Delegated Report

Householder Planning Application

Planning Application No: 20230524

Description: Erection of a first floor rear extension with a flat roof.

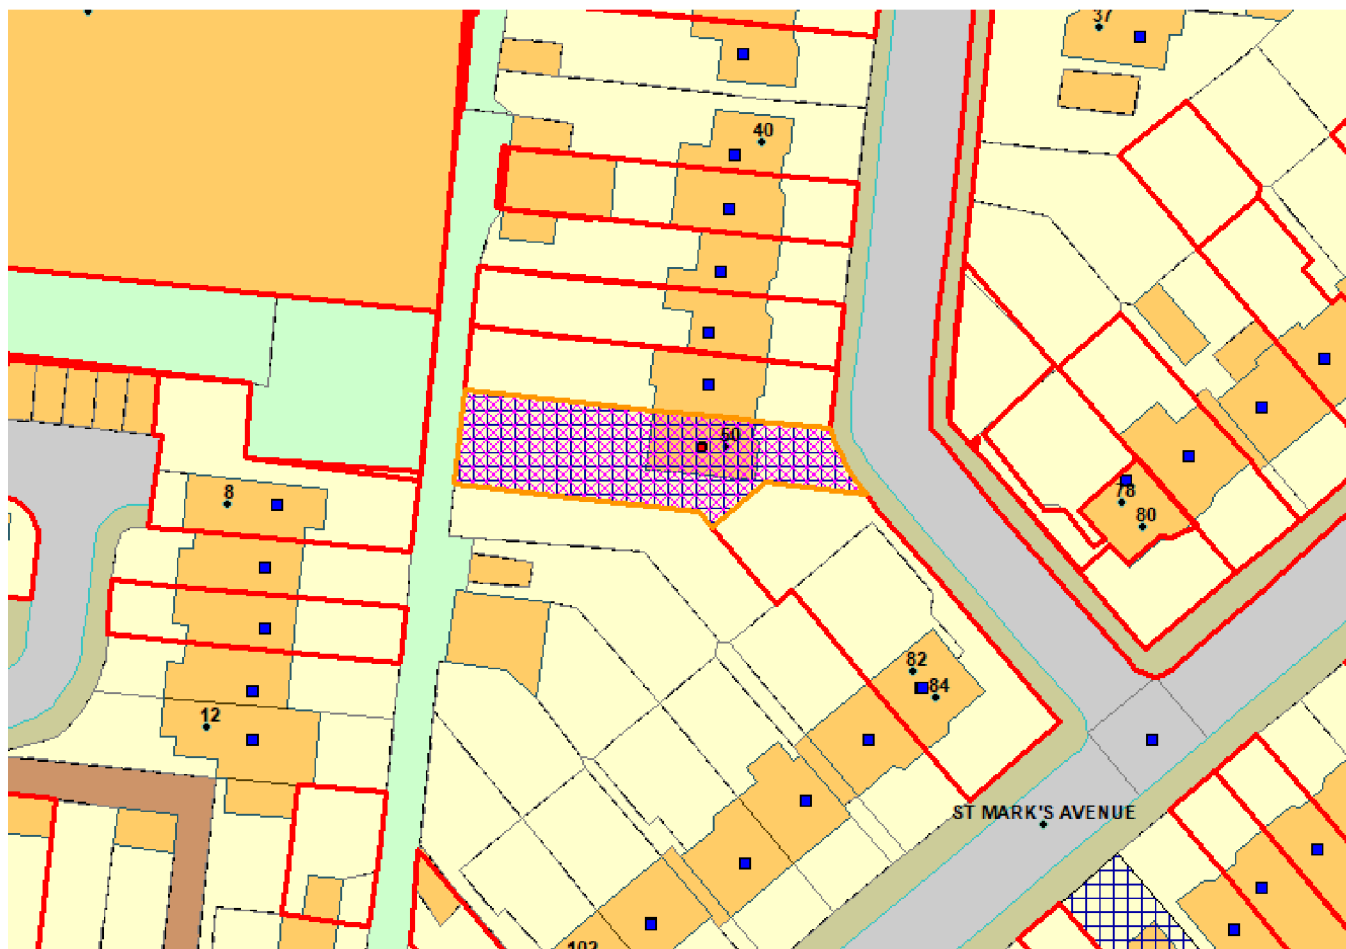
The proposed first floor rear extension would be of a modest depth and width. However, in terms of height, the extension would be excessive as it would exceed the eaves height of the host dwelling. Furthermore, the proposed extension would have a flat roof which would be out of keeping with the host dwelling which has a pitched roof. The proposed extension also 'cuts into' the mansard roof form of the existing two storey out-rigger thereby causing harm to this design detail which makes up part of the character of the rear elevation of the dwelling.

Overall, the proposed extension due to it being greater in height than the eaves level of the host dwelling, having a flat roof design which is not in keeping with the roof form of the host dwelling and the juxtaposition with the existing mansard roof detailing on the out-rigger would create an extension that would not be

subservient to the host dwelling and would be of an incongruous design out of keeping with the scale and character of the host dwelling. The positioning of the extension above the eaves level and the flat roof design would be visible in part from Marina Drive to the south and the proposed extension would therefore also be harmful to the streetscene at this point.

The proposal would not increase the number of bedrooms at the property (it would only increase the size of existing bedroom no. 2) and as a first floor extension is proposed it would not alter the existing garden area or depth at all.

The proposed extended bedroom no. 2 would be increased from 8 sq. m to 14.5 sq. m and would therefore exceed the minimum standard for a double bedroom as set out in the Technical Housing Standards (2015) which is 11.5 sq. m.
